1 Introduction

This document provides responses to the submission made by Government Agencies in response to the new Sydney Fish Market Stage 2 State Significant Development (SSD) Application (SSD DA 8924 & 8925). The following sections provide a summary of the submission and the associated response from the project team. The agency submissions reviewed in this document are as follows:

2 Response to Transport for NSW Submission

Figure 1 Existing heavy vehicle traffic generation

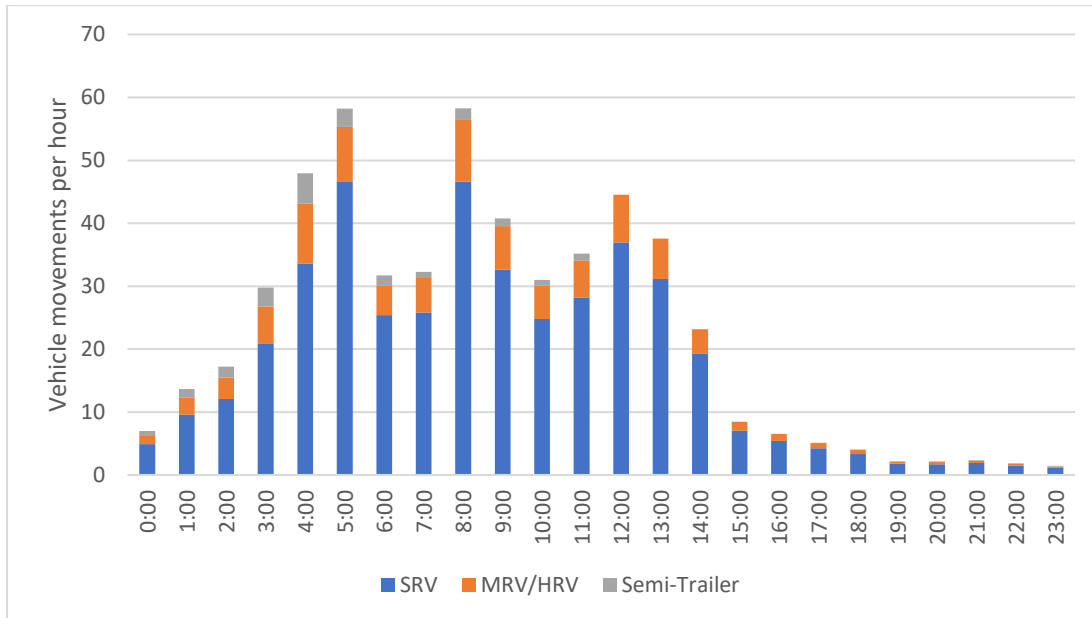
- Traffic generation by heavy vehicles during the existing Fish Markets operation, including movement of heavy vehicles (by type and duration of stay) across a 24-hour period;
- Details of the development's freight and servicing profile, including the forecast freight and servicing traffic volumes by vehicle size, frequency, time of day and duration of stay;
- Assessment of the proposed loading and servicing facilities to adequately accommodate the future demand; and
- Details of the management of deliveries, including the scheduling of delivery times (outside of peak periods where possible), controls on duration of stay and queuing.

Extensive surveys were undertaken in 2018 to understand the level of service vehicle traffic generated by the existing Sydney Fish Market site. This level of traffic generation, separated by vehicle type, is presented in Figure 1.

Figure 5 Forecast taxi and ride-share movements

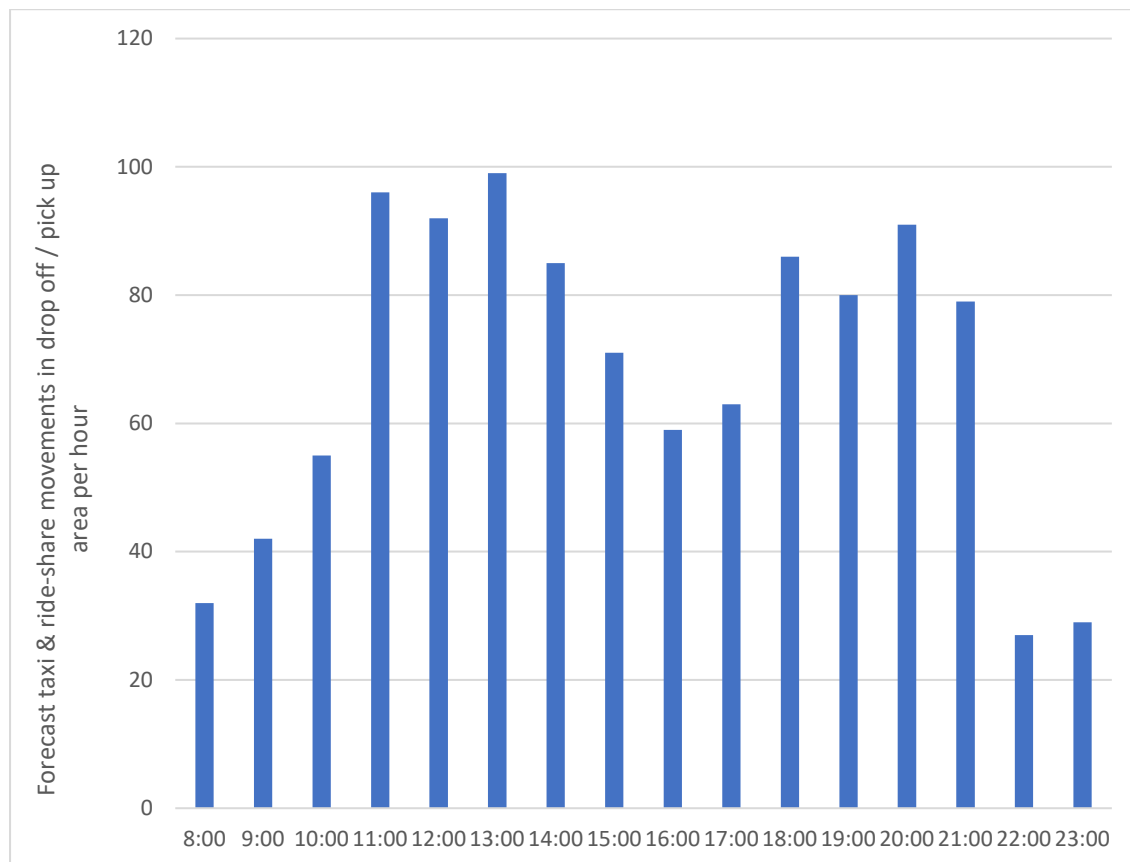
- Forecast bus, coach and point to point vehicle movements by vehicle size, frequency, time of day and duration of stay;
- Investigation into the provision of off-street bus and coach parking and vehicle drop off and pick up area, rather than reliance on on-street kerb space;
- Assessment of the proposed bus and coach parking and vehicle drop off and pick up area to adequately accommodate the forecast demand.

The forecast number of taxi and ride-share movements by hour on a typical weekday is presented in Figure 5, with total forecast coach / mini-bus movements shown in Figure 6.

Figure 7 Sydney Bike Network

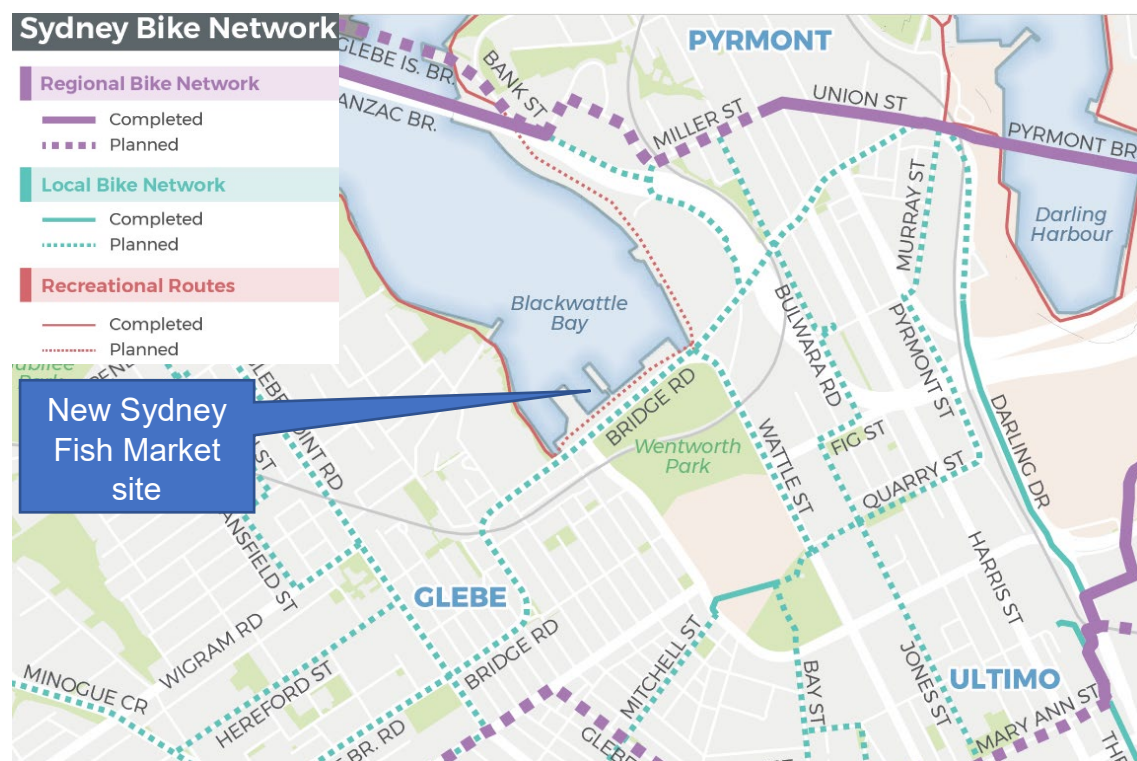
- Investigates providing new off-road cycling connection on Bridge Road in accordance with the relevant Austroads cycling standards;
- Further details on the off-road cycling connection and how it integrates with the surrounding cycle network and an assessment of road safety at key intersections and locations subject to pedestrian / vehicle / bicycle conflicts along Bridge Road be provided as part of the applicant's response to submissions;
- Appropriate wayfinding and signage to assist staff and visitors in locating the light rail stops, bus stops and bicycle parking and end of trip facilities; and
- Bicycle parking and end of trip facilities in easily accessible locations.

The provision of a shared path along the northern side of Bridge Road, which will primarily cater for recreational and less confident cyclists, aligns with the broader City of Sydney bike network as shown in Figure 7. This plan indicates a planned recreational route along the northern side of Bridge Road and through the existing Sydney Fish Market site to connect with the regional bike network at Miller Street, as well as link up with the existing recreational route along Blackwattle Bay.

Figure 8 Vehicle / cyclist conflicts with dedicated cycleway on Bridge Road

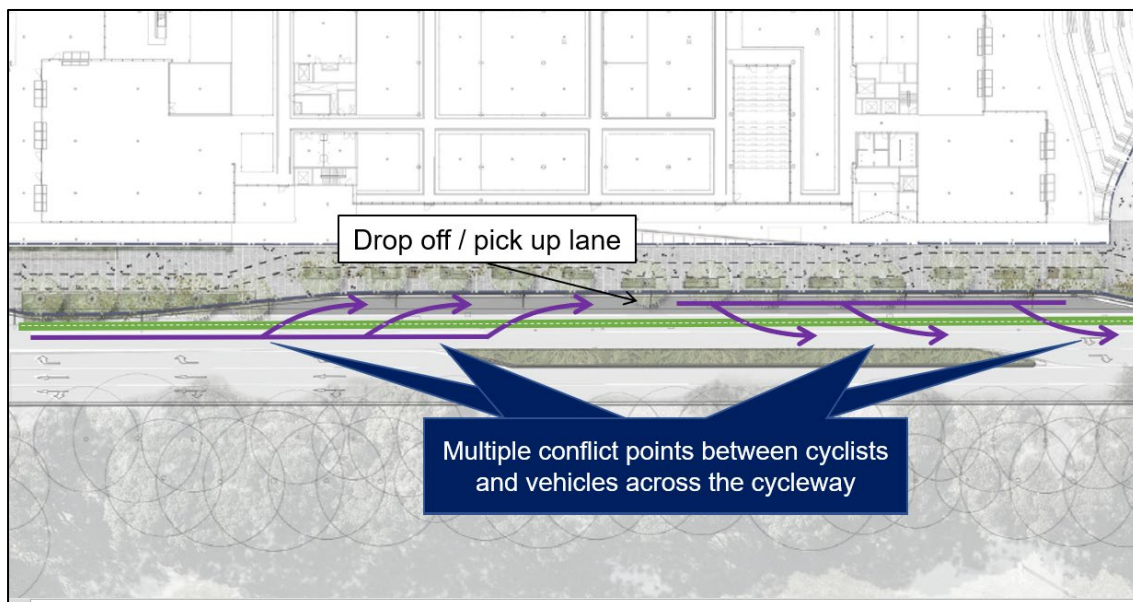
<p>There is expected to be a high number of pedestrians walking throughout the front promenade. Consideration shall be provided for a dedicated cycle way as the shared path will likely introduce safety concerns when mixed with moderate to high speed commuter cyclists.</p>	<p>Justification for the introduction of a shared path along Bridge Road, rather than a dedicated cycleway, is discussed in Section 2.5 of this document.</p>

This option would involve providing a separated cycleway on the northern side of Bridge Road, adjacent to the traffic lane. While this option would have the benefit of separating pedestrians and cyclists, it would result in significant conflict points and safety concerns with the adjacent pick up and drop off lane. As the cycleway would run parallel to the pick up and drop off lane, significant numbers of coaches, minibuses, taxis and other vehicles would conflict with cyclists as they enter and exit the area (see Figure 8). A continuous roll-over kerb would be required along the length of the cycleway to permit vehicles to enter and exit the drop off/pick up lane, which limits the ability to physically separate cyclists from adjacent traffic. Less confident cyclists in particular would feel vulnerable in this environment.

Given these safety concerns the option of a dedicated cycleway on the northern side of Bridge Road was not considered viable.

Figure 10 Future year Wattle Street / Bridge Road layout

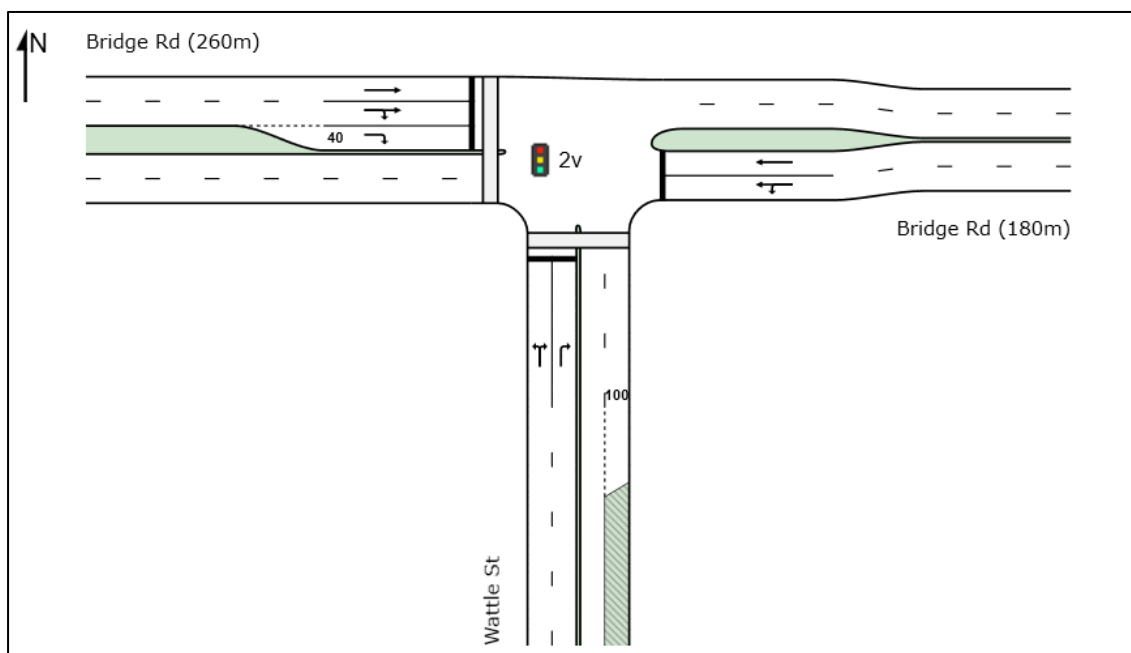
Additional justification shall be provided for the removal of the left turn slip lane at TCS1200 considering the high importance of this section to the network.

- (i) Removal of the existing left turn slip lane from Wattle Street into Bridge Road; and
- (ii) Reallocation of existing exclusive through lane on Bridge Road (west) to become a shared through/right turn lane. This was identified in the modelling as a suitable measure to manage the increased right turning traffic flows from the new Sydney Fish Market development from Bridge Road onto Wattle Street.

The assumed layout is shown below in Figure 1

Figure 12 Future year Bridge Road / Wentworth Park Road layout

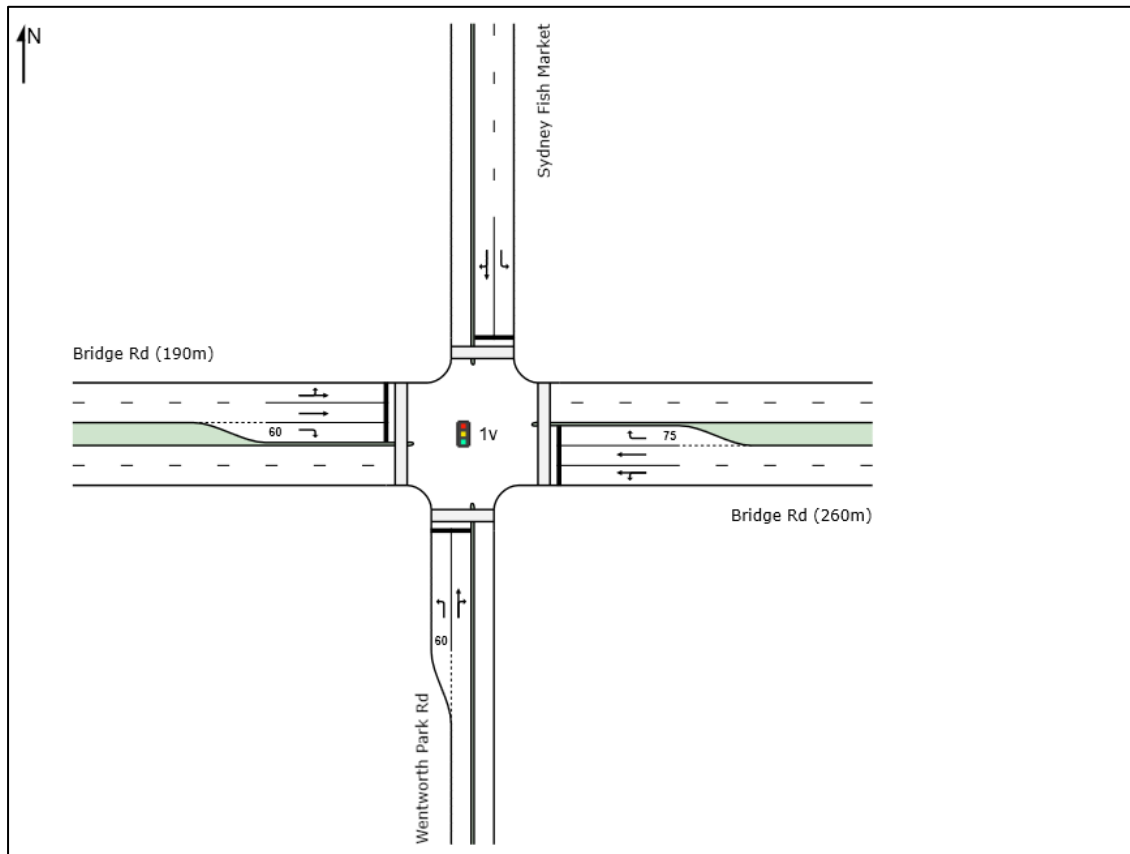
TCS1200 (Pyrmont Bridge/Wattle) is coordinated with TCS230 (Pyrmont Bridge/Western Distributor/Bank St). TCS1835 (Pyrmont Bridge Rd/Pyrmont Bridge St), TCS5 (Pyrmont Bridge/Harris) and TCS230 are also coordinated. Modelling is to be revised to reflect the TCS coordination. Also during peak periods (including weekend peak periods), the cycle time operates at the maximum cycle time of 120 seconds for all signalised intersections.	Following discussions with Transport for NSW, a SIDRA Network model has been developed which considers the operation of these intersections as a network rather than in isolation. The results of the SIDRA network modelling are detailed in Section 3.6 of this document.
The proposed new TCS at Wentworth Park Rd/Bridge Rd intersection is within close proximity to TCS1200 and TCS230. The new proposed signals will be need to be coordinated with TCS1200 and TCS230.	
While pedestrian amenity will be improved, the installation of a marked foot crossing on the eastern approach of Bridge Road along with the removal of the slip lane from Wattle Street will result in delays for all vehicles coming from Wattle Road due to the requirement for full pedestrian protection. An exemption of this pedestrian leg should be sought or use of flashing amber arrows used to increase traffic flow.	Traffic modelling has confirmed that the proposed changes to the Bridge Road / Wattle Street intersection result in acceptable impacts on the road network, as detailed in Section 3.6 of this document. Further justification for the removal of the slip lane is provided in Section 3.4.

To facilitate efficient vehicle access into the new Sydney Fish Market site, as well as to provide for enhanced pedestrian connectivity, traffic signals are proposed at the Bridge Road / Wentworth Park Road intersection. The assumed layout is illustrated in the figure below.

Following advice from TfNSW however, the updated modelling has considered a 120 second cycle time. As a result of this increased cycle time, the modelling indicates that the maximum queue in the right turn bay on Bridge Road (turning into the new Sydney Fish Market) is forecast to be approximately 95m – exceeding the available bay length of 75m. Should TfNSW maintain the requirement to operate the proposed traffic lights at a 120 second cycle time during the weekend peak hour, it is recommended that investigations be undertaken into the feasibility of extending the turn bay by 20m.
